BULLETIN #153

FEBRUARY 2001

MODELS AFFECTED	P-80
SUBJECT	IMPROVED MASTER PISTON RETAINER

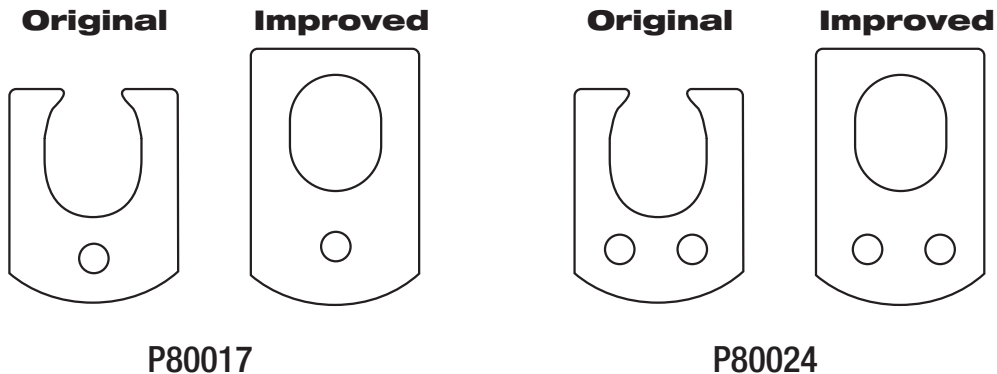
Pacbrake engineering has released an improved master piston retainer for use on model P-80 engine brakes. The improved retainer uses the same part number as the original, as it is a direct replacement. Two versions of the early retainer exist, a single fastening hole and a dual fastening hole.

Engine brake housing serial numbers 080000 to 088088 require the single screw hole retainer P/N P80017 and housing serial numbers 088089 to current require the dual screw hole retainer P/N P80024.

A bridge between the two legs identifies the improved retainer. (See illustration below).

Parts orders will be filled with the improved retainer and any inventory of the obsolete retainers may be returned to the factory for replacement with the improved type.
